TORONTO STAFF REPORT

August 23, 2006

Subject: Final Report
OPA & Rezoning Application 06 124318 NNY 23 OZ
Applicant: Moiz Behar, M. Behar Planning And Design
Architect: N/A
65 and 67 Finch Ave West
Ward 23 - Willowdale

Attachment 1: Site Plan

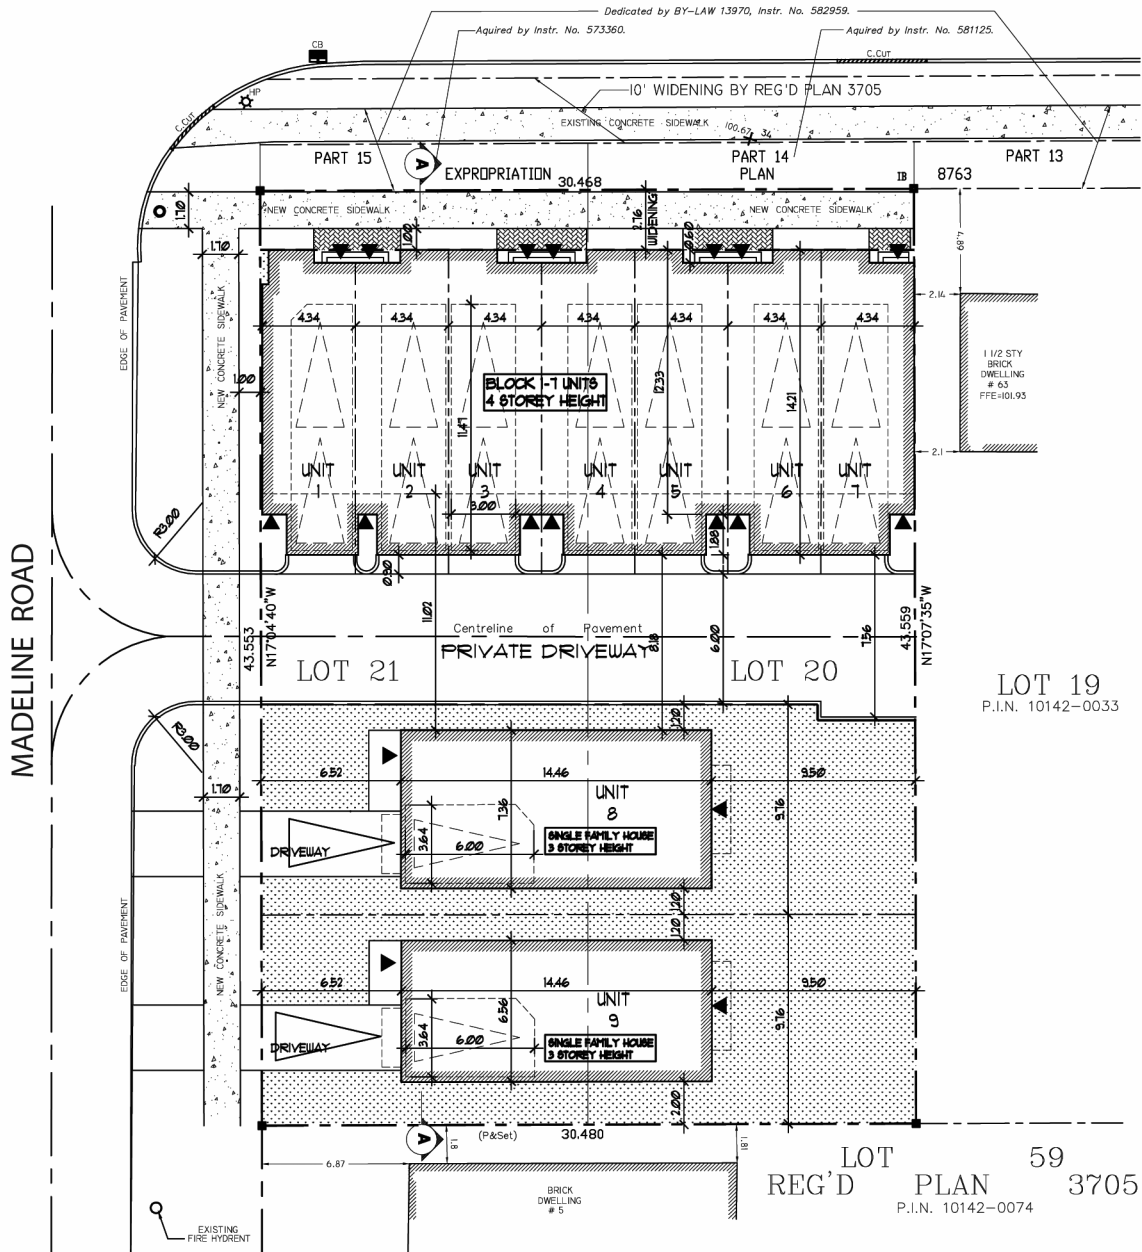
4. The City's planting detail has not been shown on the submitted plans. Trees indicated for planting on the City road allowance must be planted in accordance with the Tree Details Section of the City of Toronto Streetscape Manual as per the details noted below. Please note that the applicant must conduct an investigation of underground utilities prior to proposing tree planting within the City road allowance. If planting is not possible due to a utility conflict, a utility locate information sheet from the respective utility company should be provided to the City.

10. Northerly and southerly entrance curb radii of 3.0 metres shall be provided for the Madeline Road access to the seven (7) proposed townhouse units and this must be shown on the site plan drawing.

11. Zoning By-law 7625 requires that each of the driveways for the detached dwellings fronting onto Madeline Road must be a minimum of 3.0 metres wide. The Driveway Entrance Policy for Residential Properties requires a minimum driveway width of 3.0 metres and a maximum driveway width of the garage, but not to exceed 6.0 metres. The ultimately approved site plan drawing illustrates the width dimensions of each of the single detached dwelling driveways complying with the above. Further the access driveway must show a depressed curb extending through the driveway, in accordance with municipal standards.

13. The required 2.76 metres Finch Avenue West road widening must be shown in all plans.
14. The Finch Avenue West sidewalk (1.7 metre wide) must be relocated to 1.0 metre from the widened property line and shown on all plans.

15. A 1.7 metre wide concrete sidewalk (1.0 metre from the property line) shall be constructed on Madeline Road boulevard and shown on all plans.
16. The site plan fails to address the following with respect to fire access route requirements of the Ontario Building Code:

- i) Hydrant located no more than 45 metres from a fire department Siamese connection (Townhouse Block standpipe system);
 - ii) Hydrant located no more than 90 metres from the "principal entrance" for buildings without a fire department connection (3 storey single homes detached);

- iii) Hydrant located no more than 90 metres horizontally from all points along the perimeter of the building face required to face a street (Townhouse Block);

- iv) The four storey Townhouse Block shall comply with Part 3 Ontario Building Code requirements for fire alarm system and standpipe and hose system.
